NEPA/CEQA RE-VALIDATION FORM

DIST-CO-RTE: 4-ALA-84, 4-ALA-680
PM/PM: ALA-84 17.9/22.9, ALA-680 10.3/15.3
EA or Fed-Aid Project No.: 04-297631
Other Project No. (specify): 0415000040
Project Title: SR 84 Expressway Widening and SR 84/I-680 Interchange Improvements Project
Environmental Approval Type: Environmental Impact Report/Environmental Assessment with Finding of No Significant Impact
Date Approved: May 30, 2018
Reason for Consultation (23 CFR 771.129), check one: <input type="checkbox"/> Project proceeding to next major federal approval <input checked="" type="checkbox"/> Change in scope, setting, effects, mitigation measures, requirements <input type="checkbox"/> 3-year timeline (EIS only) <input type="checkbox"/> N/A (Re-Validation for CEQA only)
Description of Changed Conditions: The SR 84 Expressway Widening and SR 84/I-680 Interchange Improvements Project has been modified from the original design. A detailed description of changed conditions is included in the continuation sheets and a revised ECR is attached.

CONTINUATION SHEET(S)

Figure 2: Conceptual Mitigation Map

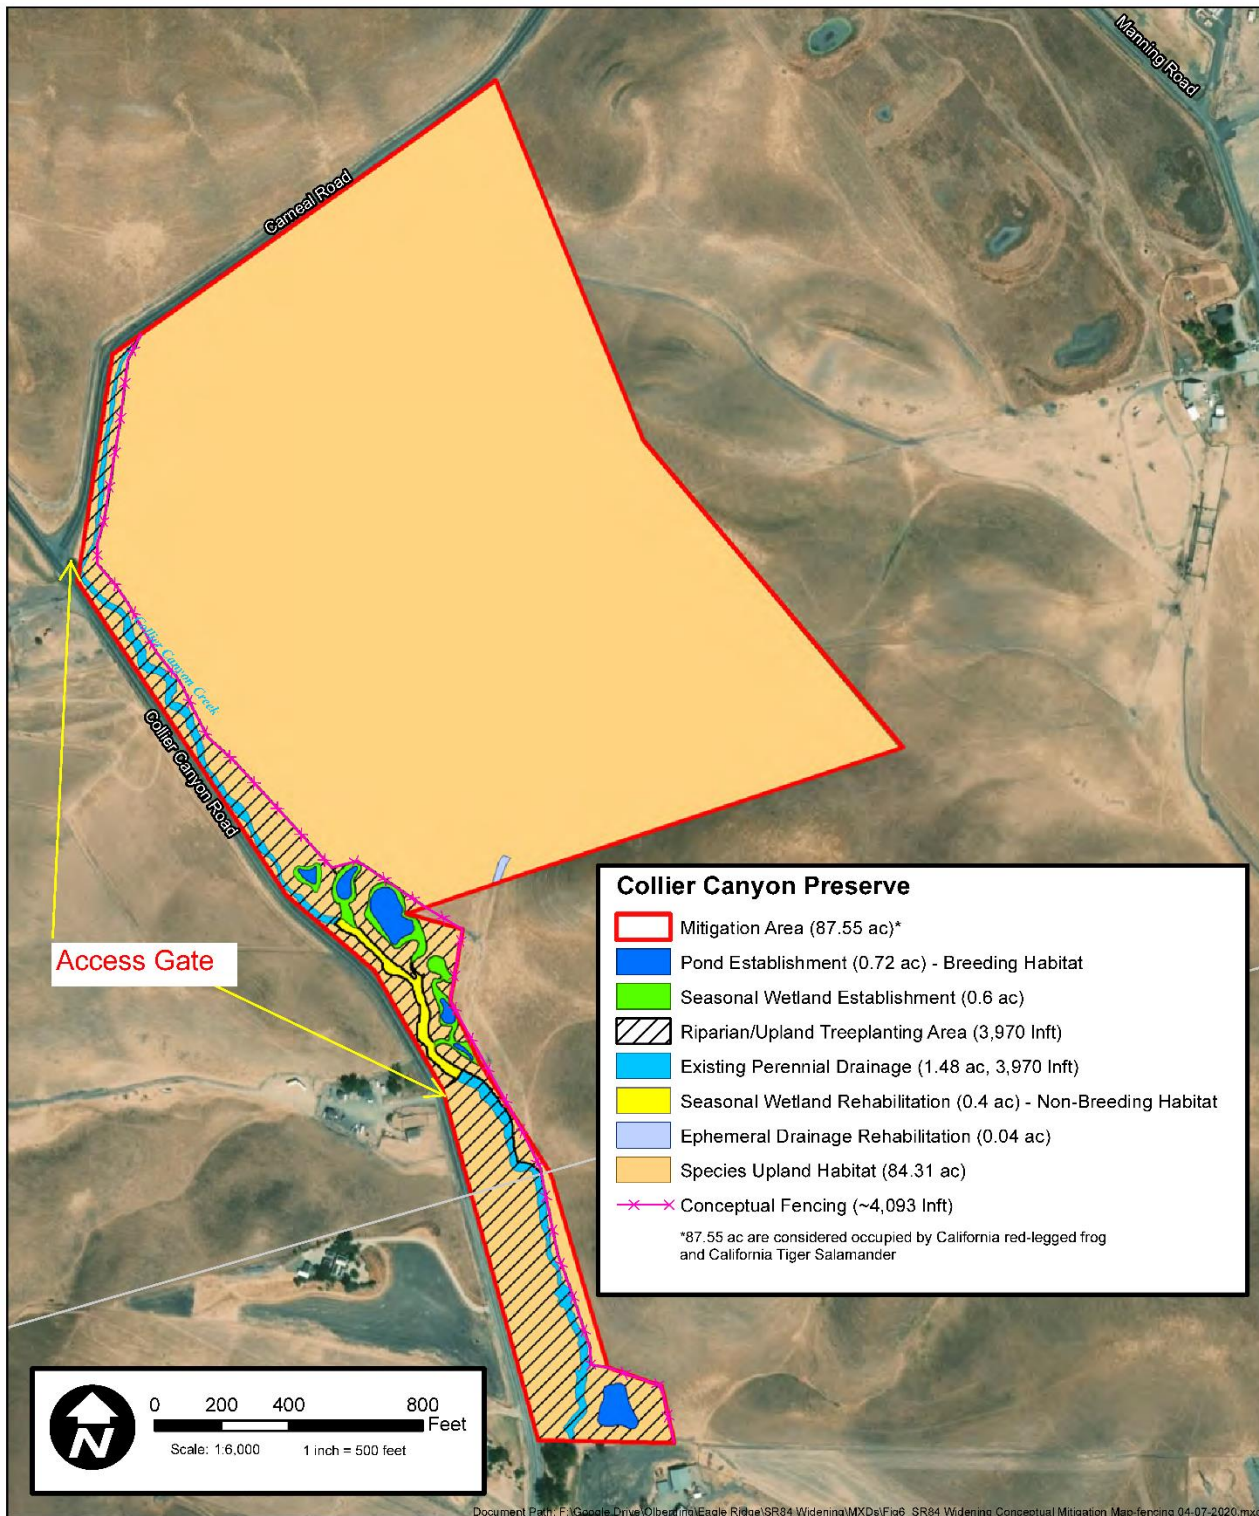
Approval of Collier Canyon Mitigation and Conservation Bank is still pending; as a result, the project team coordinated with the facility owners to develop a permittee-responsible mitigation project (Mitigation Project) at a subset of the bank property, which has since been removed from the bank boundary. The Mitigation Project consists of the same activities in the same areas as originally proposed for the mitigation bank. Figures 1 and 2 show the Mitigation Project area and proposed enhancement activities.

- Grading to create seasonal wetland and pond habitat as potential breeding, foraging, and cover for California tiger salamander and California red-legged frog;
- Increasing hydrologic function and habitat management to rehabilitate seasonal wetland and ephemeral drainage areas;
- Planting of riparian trees; and
- Habitat management to rehabilitate annual grassland to improve ecological functions for California tiger salamander and California red-legged frog.

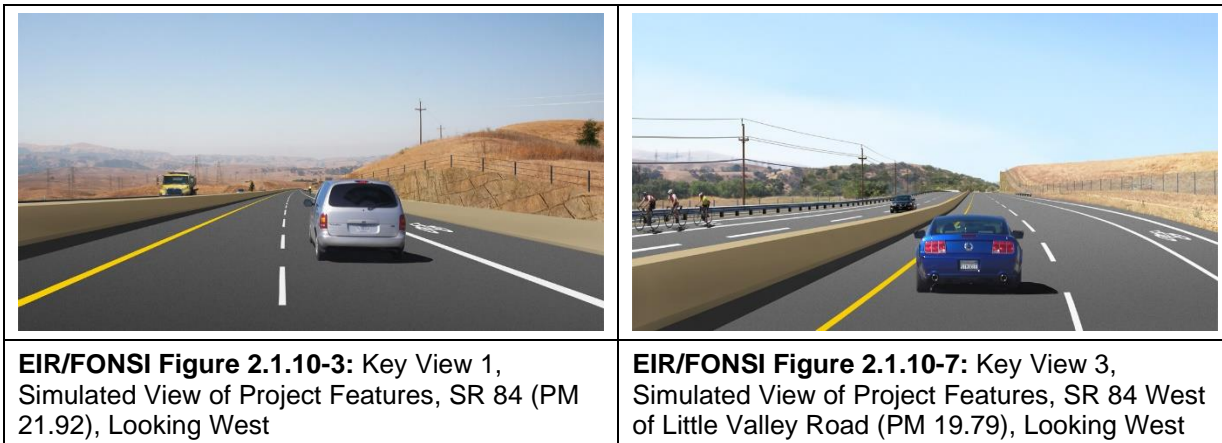
From the perspective of motorists on I-680, the mature trees along southbound I-680 would be removed from foreground views, providing greater exposure to views of agricultural fields with hay/grain crops beyond the trees to the west. The fields are flat and typically green in the winter and spring and golden in the summer and fall. Although the 290 new coast live oak trees that will be planted to provide replacement shielding will take several years to reach the height of the existing trees to be removed, views of the agricultural fields provide a pleasing contrast to the tree-studded hills that surround this valley in each direction. In addition, these native oak trees will replace many non-native ornamentals, some of which are considered invasive species. For eastbound travelers on Paloma Way, the I-680 corridor would be somewhat more visible in mid-range views toward the east-southeast, but the thin gray line of the freeway would not be prominent in comparison to mature trees in the foreground along Paloma Way, the agricultural fields beyond them, and the tree-studded hills in each direction of longer-range views.

In summary, tree removal along southbound I-680 would change views for motorists on I-680 and Paloma Way, but the change would not adversely affect the quality of the views. When the trees in the replanted area mature, they will form a native oak woodland, and views will be similar to existing conditions. As stated in EIR/FONSI Section 2.1.10.3, "The project ... would not degrade the vividness of existing views [on I-680] because the height and magnitude of the mountains and peaks in the distance would still be visible and appreciated in much the same way as in the existing view." Visual impacts from the perspective of northbound and southbound I-680 motorists would remain from moderate-low to low.

This project change would not have an adverse effect on the Officially Designated State Scenic Highway designation in this area because it would not increase the intensity of development, introduce outdoor advertising, or add structures or highly visible equipment. The project change reflects detailed site planning (consistent with SFPUC's objectives for the property) and careful attention to landscaping.
